Subject: Response to Request for Additional Information
Application for Ocean Shore Alteration Permit
Maxine and Martin Siegel (Property at 3915 Ocean Ave)

This letter responds to your request for additional information dated July 10, 2026, related to the above-referenced application. We have updated the application form and materials to address the following:

Proposed Shoreline Protection Structure
3915 Ocean Avenue
Cannon Beach, Clatsop County, Oregon

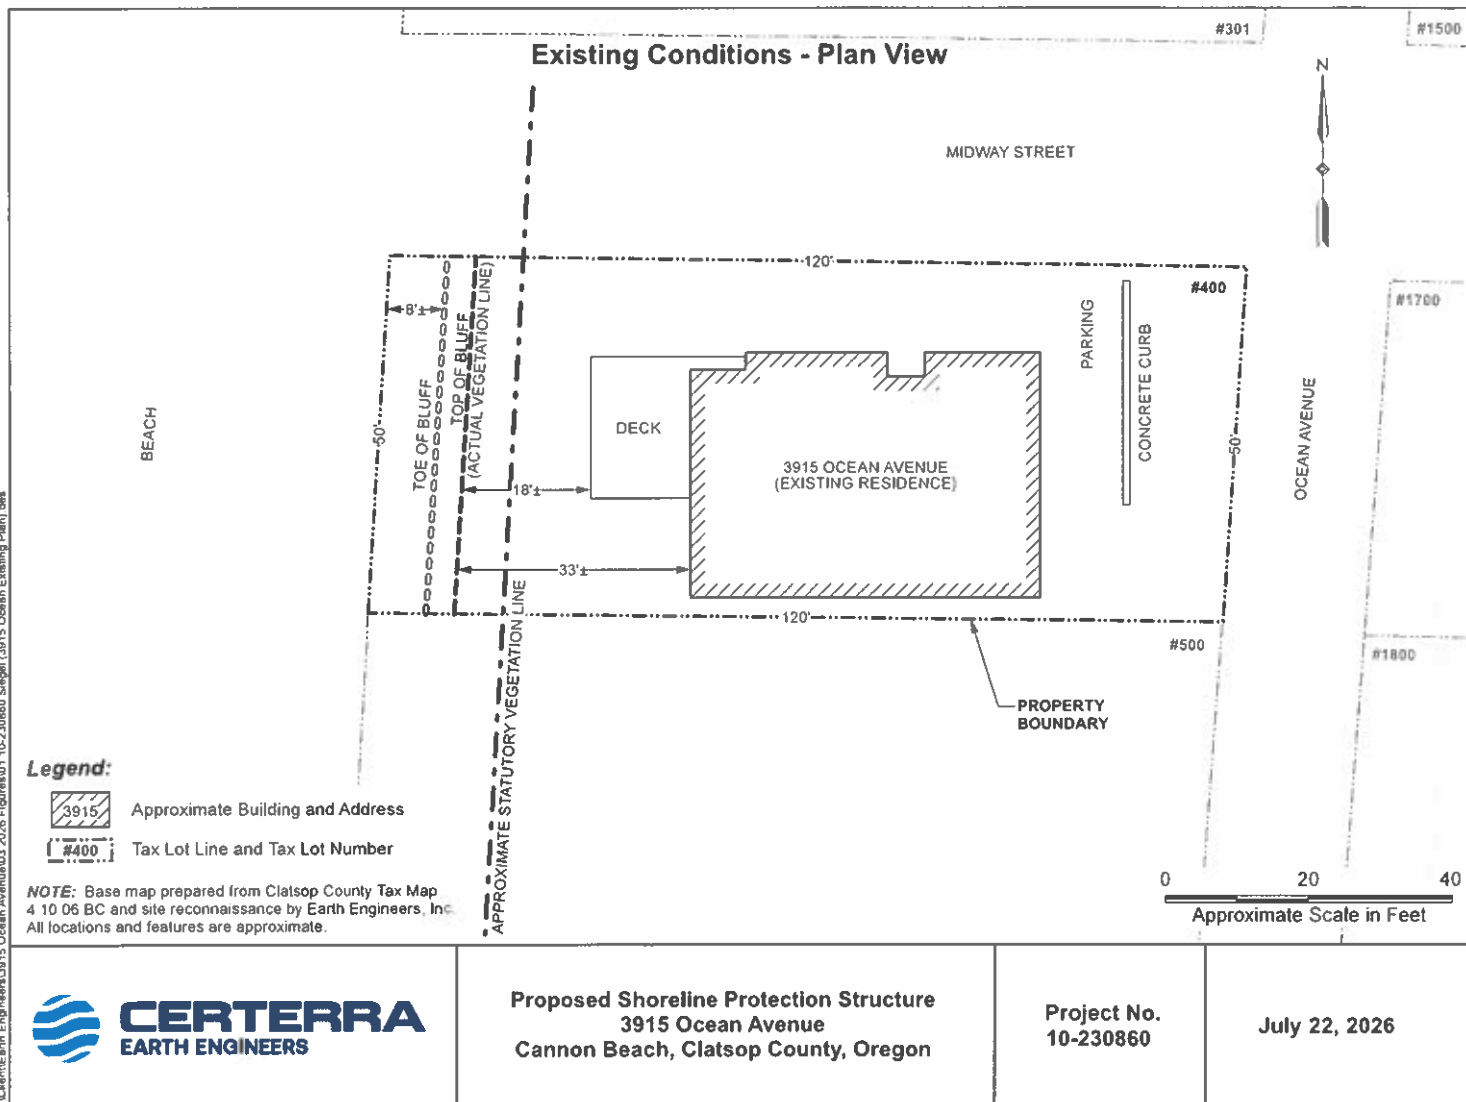
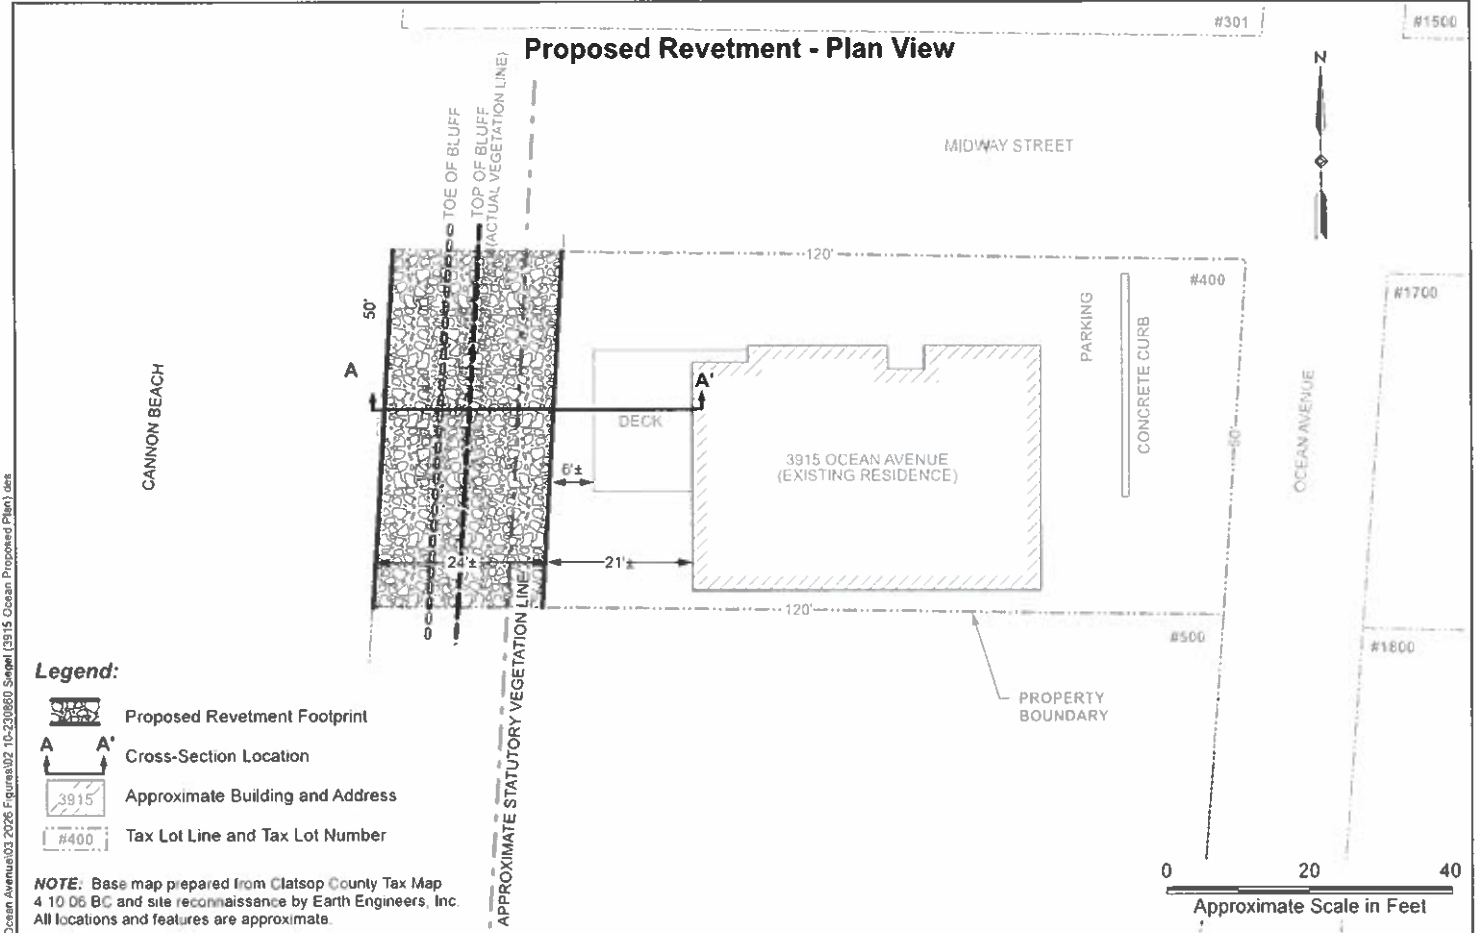
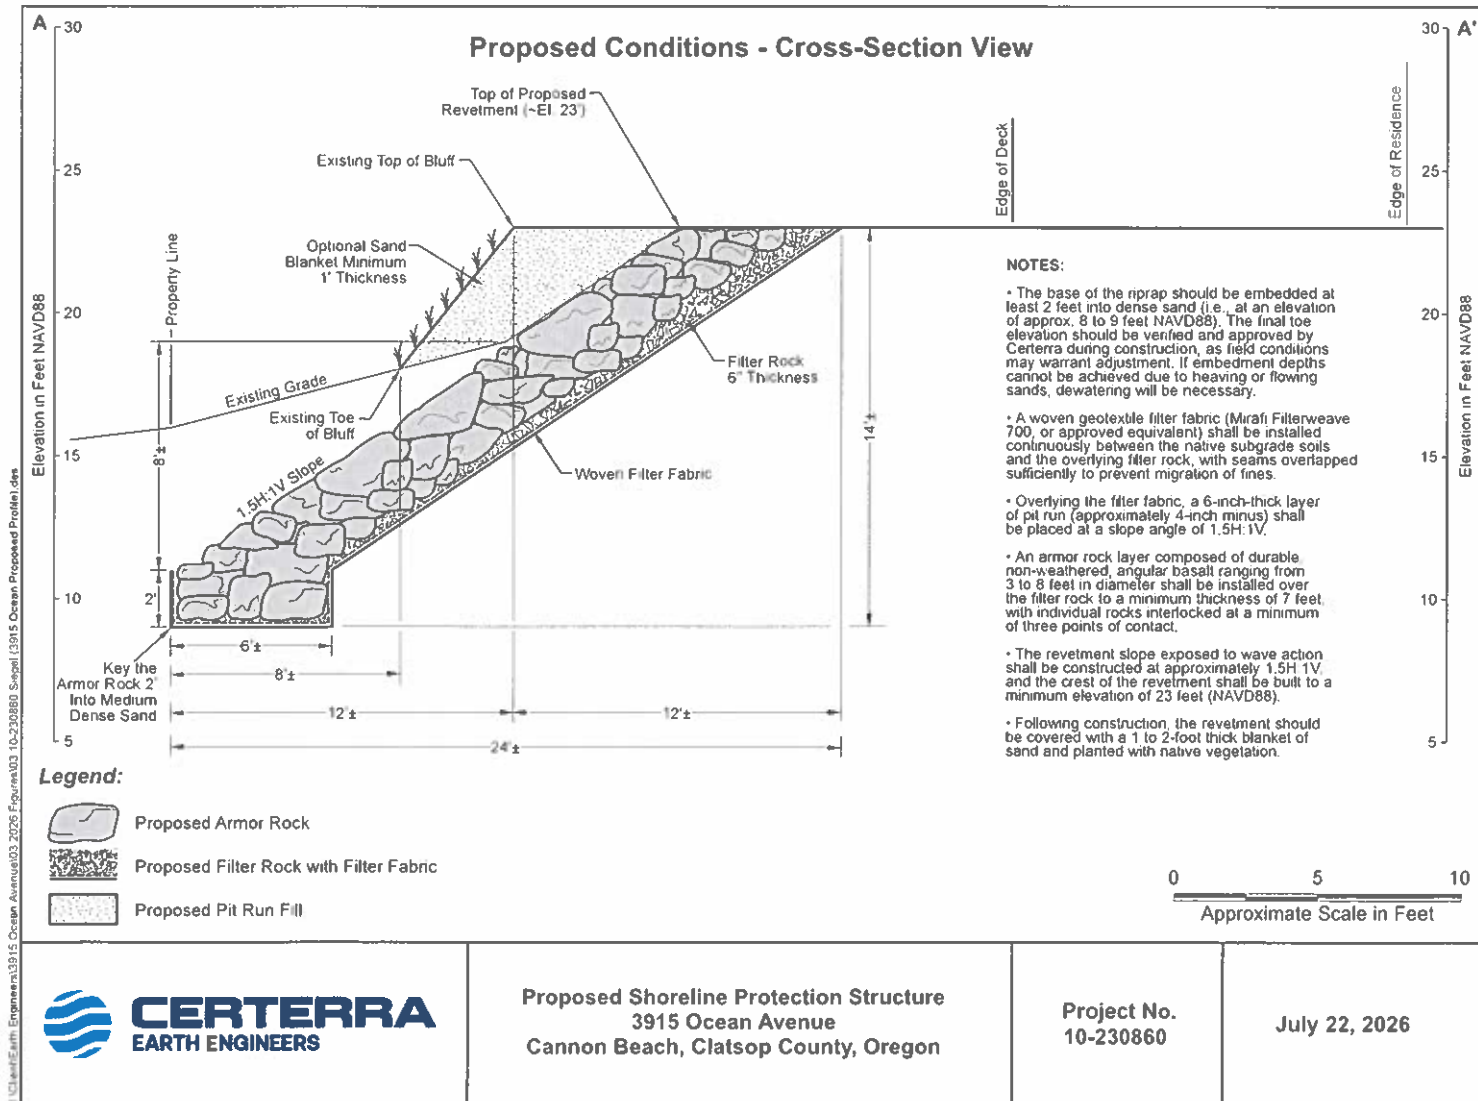
Section 10 – Required Drawings (*Plan view does not provide all required elements. Profile view OK.*).

Certerra has submitted updated plan view sheets dated July 22, 2026, to more clearly show the required elements, and those updated drawings have been included in the application materials.
